| Safety Recall Campaign | 2012-2017MY Rio (UB) |
| SC284UB | April 2024 |

SAFETY RECALL CAMPAIGN

HECU FUSE REPLACEMENT (SC284UB)

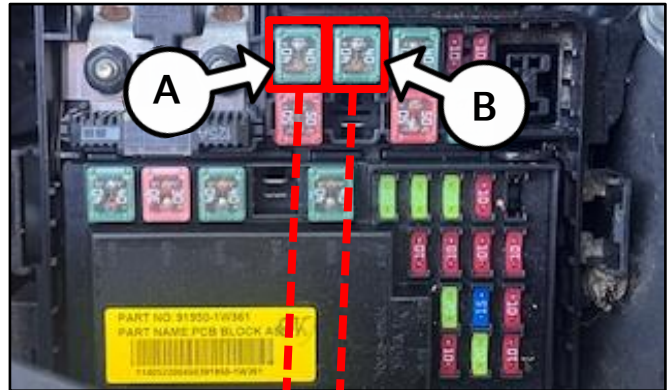
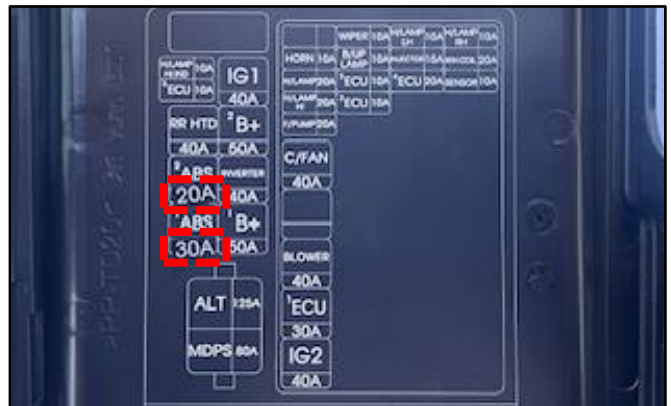
- 3a. Remove both existing HECU ABS1 40A (A) and ABS2 40A (B) fuses.

- 3b. Install new amperage fuses:

- ABS1 fuse (A) → new 30A
- ABS2 fuse (B) → new 20A

Ensure to replace ABS1 fuse (A) with the 30A fuse and ABS2 fuse (B) with 20A fuse.

4. Adhere the new ABS1 30A and ABS2 20A labels to the bottom of the junction box fuse cover, as shown.
